Subject: Amended MHI's Response to US-APWR DCD RAI No. 694-5355 REVISION 1 (05.03.02)

Amended Response to Request for Additional Information
No. 694-5355 Revision 1

RAI NO.: NO. 694-5355 REVISION 1

QUESTION NO.: RAI 05.03.02-11

Figure A1-3 Generic P-T Limit Curves for Heatup

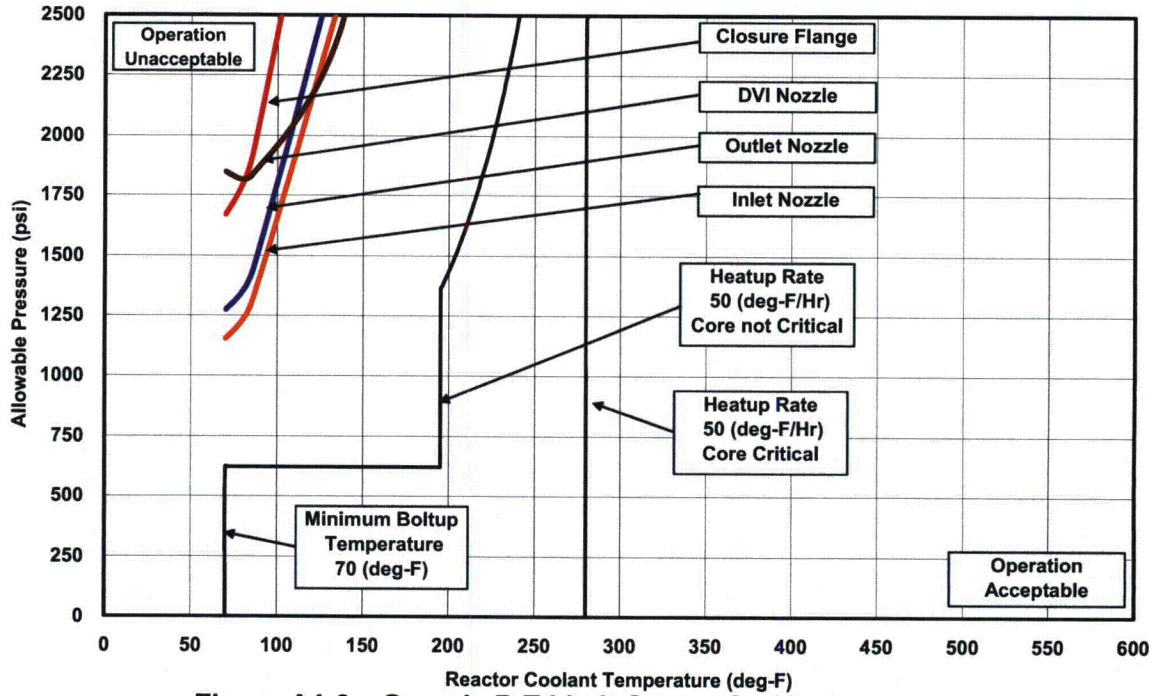
The US-APWR Pressure and Temperature Limits Report (Technical Report MUAP-09016) describes how the P-T limits for the US-APWR reactor vessel have been developed based on the evaluation of the beltline and closure flange regions. However, MUAP-09016 does not mention any consideration given to the vessel nozzles. Clarify how the analyses performed to develop the P-T limits for the US-APWR design has considered the entire reactor vessel, including the beltline, closure flange, and nozzle regions.

The fracture mechanics evaluation on the US-APWR reactor vessel is subsequently performed using stress analysis results. The fracture mechanics evaluation results including vessel nozzles are attached as Attachment-1 (Refer to Technical Report MUAP-09016 Revision 3), and shows the evaluation for the beltline and closure flange regions is conservative compared with those for vessel nozzles.

Attachment-1
 Result of Fracture Mechanics Evaluation for Beltline and Closure Flange Regions
 Compared to Those for Vessel Nozzles (Referred to Technical Report MUAP-09016
 Revision 3)
